**SUBJECT:** COMANCHE PEAK NUCLEAR POWER PLANT, UNITS 3 AND 4  
DOCKET NUMBERS 52-034 AND 52-035  
SUPPLEMENTAL INFORMATION FOR RESPONSES TO REQUESTS FOR  
ADDITIONAL INFORMATION NO. 1889 AND 3698

### **Supplemental Response to Request for Additional Information No. 1889 (CP RAI #11)**

**RAI NO.: 1889 (CP RAI #11)**

**QUESTION NO.: 02.05.02-16**

**Figure 2.5.2-204 Dames & Moore Contributing EPRI Seismic Source Zones**

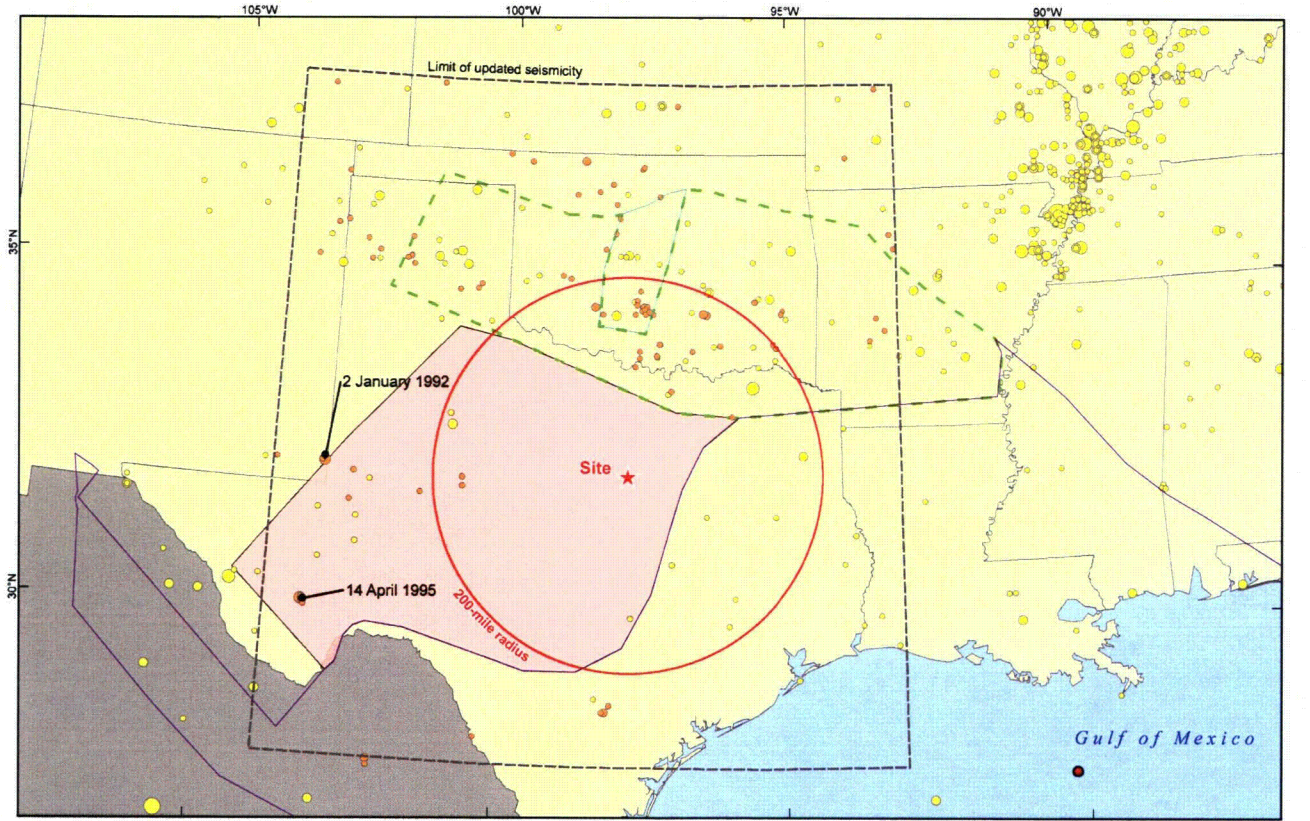
The Meers fault is about 270 km from the CPNPP site with an Mmax distribution of  $6.85 \pm 0.15$  (Table 2.5.2-213) and a dominant recurrence interval of 1265 years. Considering these parameters, the staff is unclear why the Meers source's contribution to mean hazard is almost invisible in the 1 to 2.5 Hz deaggregations, and only a small contributor to the 5 to 10 Hz deaggregations of Figures 2.5.2-223 to 227. Please explain the near invisibility of the Meers source in FSAR Figures 2.5.2-223 to 227.

During preparation of FSAR Subsection 2.5.2, the Gulf Coast ground motion equations were used for the Meers fault, whereas the Mid-Continent equations from EPRI (2004) were more appropriate. The Gulf Coast ground motion equations were also used for EPRI team sources, whereas the Mid-Continent equations were more appropriate. The New Madrid seismic zone hazard calculations have always used the Mid-Continent equations.

~~Seven source zones from the Dames & Moore Group EST defined six source zones that contributed to hazard at CPNPP Units 1 and 2 (Table 2.5.2-203) (Figure 2.5.2-204) (References 2.5-369, 2.5-370, and 2.5-335): Southern Coastal Margin (zone 20), Ouachitas Fold Belt (zone 25), Kink in Ouachita Fold Belt (zone 25a), Southern Oklahoma Aulacogen (zone 28), Default for Southern Oklahoma (zone 28b), and New Mexico (zone 67) and Combination (zone C08). Dames & Moore defined one four additional zones that extends to within the site region that did not contribute to hazard at CPNPP Units 1 and 2 (Table 2.5.2-203) (References 2.5-369, 2.5-370, and 2.5-335): B-W-M Fault (zone 29), A/W Uplift (zone 30), Ardmore Basin (zone 32) and Anadarko Basin (zone 33). Following is a brief discussion of the seismic source zones that contributed to hazard at CPNPP Units 1 and 2 and are used in the PSHA for CPNPP Units 3 and 4:~~

The South Coastal Margin source zone is a large regional zone that extends from the continental shelf off eastern Florida, along the Texas coastal plain, and into Mexico (Figure 2.5.2-204). Dames & Moore designed the zone to largely parallel the southern-rifted margin of North America, and they state that they have no tectonic basis with which to define the seismic potential of the zone. The zone is characterized by an upper-bound Mmax of  $m_b$  7.2 (Table 2.5.2-203). The closest approach of the zone to CPNPP Units 3 and 4 is 83 mi.

Figure 9.2.1-1R Essential Service Water System Piping and Instrumentation Diagram (Sheet 1 of 2)

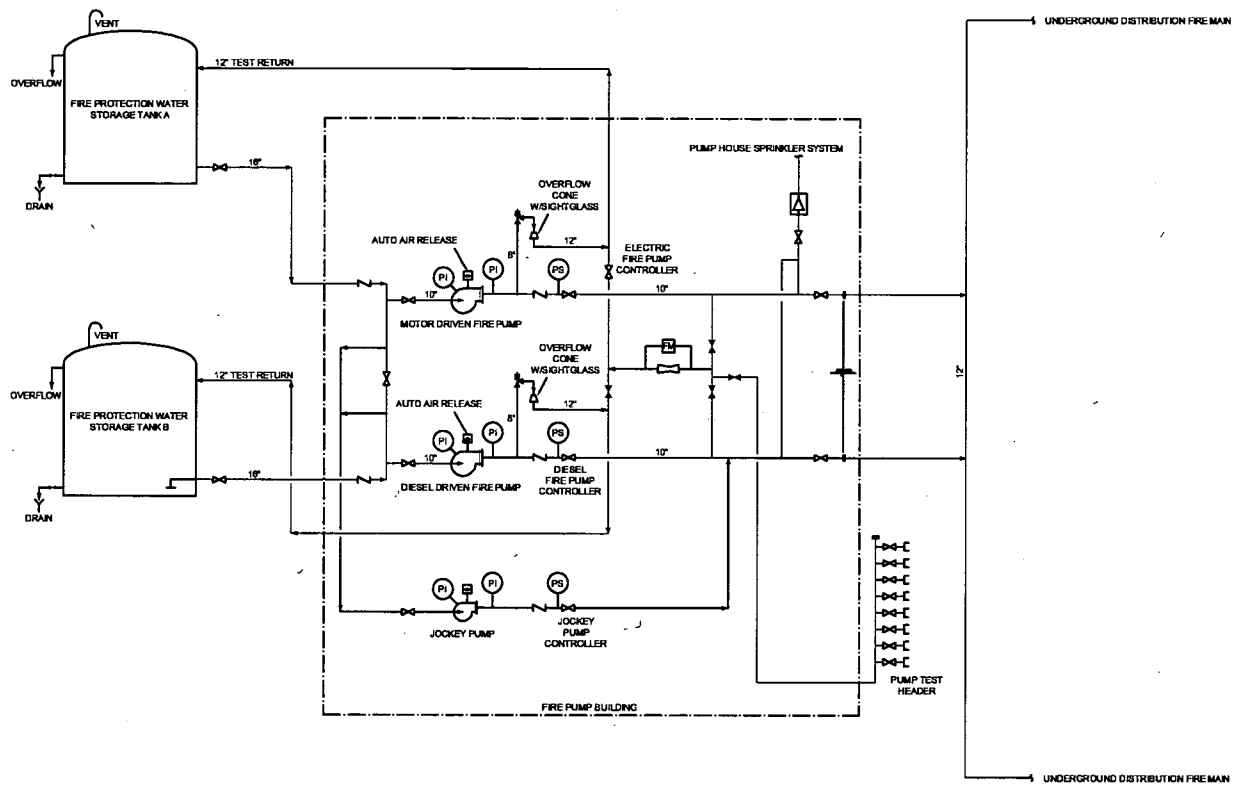
- Provide a revision to the COL FSAR identifying the cooling water system has been modified to accommodate FSS to the RB and to the ESWS pump house as a departure and provide an evaluation using the applicable criteria of 10 CFR Part 52.
  - FSAR Figure 9.2.1-1R, "Essential Service Water System Piping and Instrumentation Diagram," does not graphically show that these normally locked closed (LC) valves are connected to FSS hose stations. Revise FSAR to correctly show a hose or flange connection downstream of the LC valves.
-

In response to this question in letter TXNB-09071 submitted on November 20, 2009 (ML093280698), Luminant committed to revise FSAR Figure 9.5.1-201 to show the fire protection water supply system (FSS) interface with the essential service water system. The updated figure is attached. In addition, Notes 2 and 3 on Figure 9.2.1-1R (Sheet 1 of 2) have been revised to cross-reference new Figure 9.5.1-201 Sheet 2.
